TECHNICAL MEMORANDUM

JOB #: PACL.01.16

SUBJECT: Memo –Cilker Property Connection to Oakmead Stormwater Pump Station Data Review

Figure 1 - Cilker Property and Oakmead Pump Station Drainage

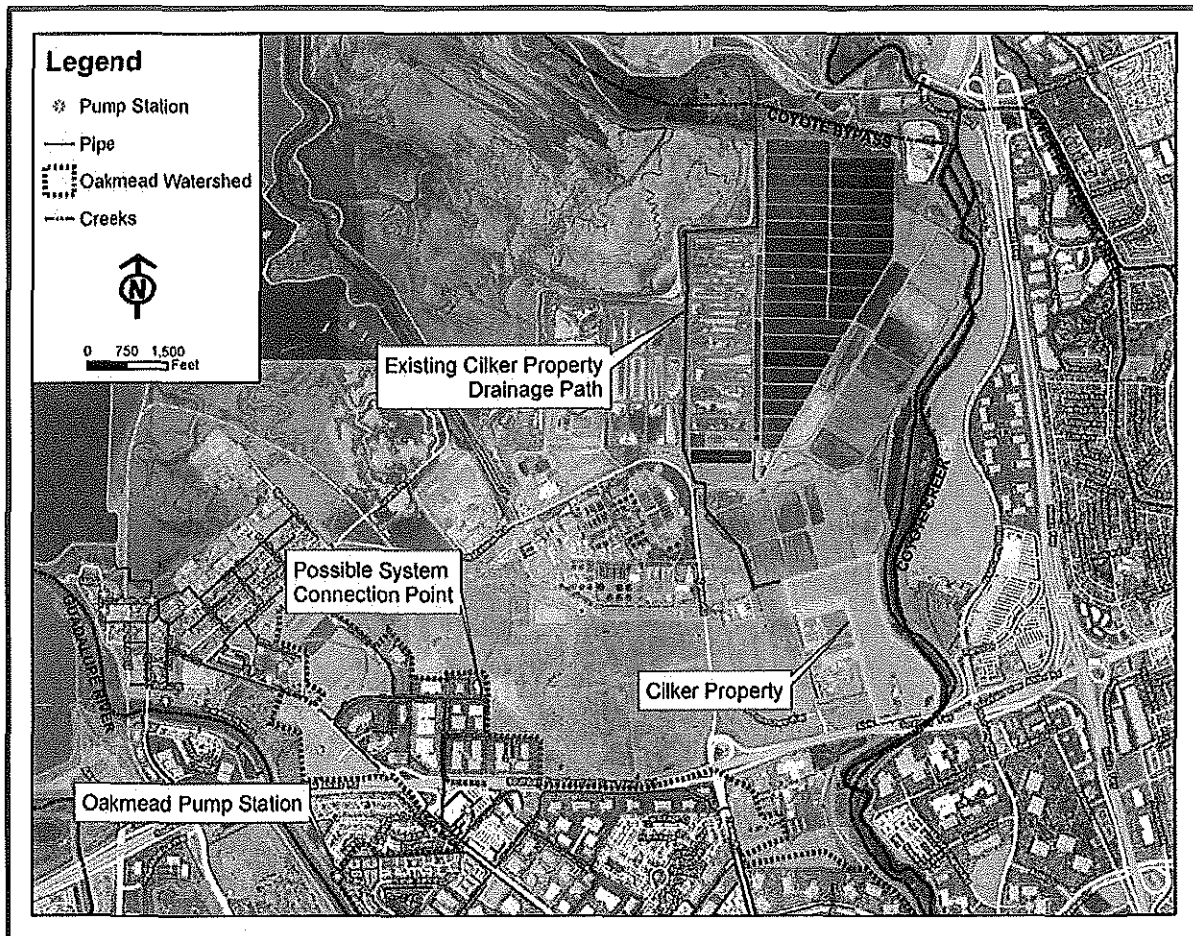
This memo summarizes the data reviewed to determine whether the Oakmead Stormwater Pump Station has adequate capacity to accommodate the Cilker Property project's post-development stormwater runoff. The site is currently not connected to the City of San Jose's storm drain system. It drains via sheet flow to a channel at the northwest corner of the property which passes through the San Jose Water Pollution Control Plant site and confluences with Coyote Creek. The developer originally proposed draining the site to Coyote Creek through a new outfall, but the City and Santa Clara Valley Water District have expressed concerns about the construction of a new outfall and altering the discharge location of the site. The City has asked the developer to review available data and determine whether directing flows to the Oakmead Pump Station by connecting site piping to the City's storm drain system at Nortech Parkway is feasible.

The Oakmead Pump Station does have adequate capacity for the addition of flows from the Cilker Project Area, but will then be functionally at capacity. If the site is connected to the City's system at Nortech Parkway then the City should ensure that any development that occurs between the site and the connection point in Nortech Parkway drains to a different pump station or outfall. An analysis should be completed to ensure that the storm drainage system between Nortech Parkway and the Oakmead Pump Station has sufficient capacity.
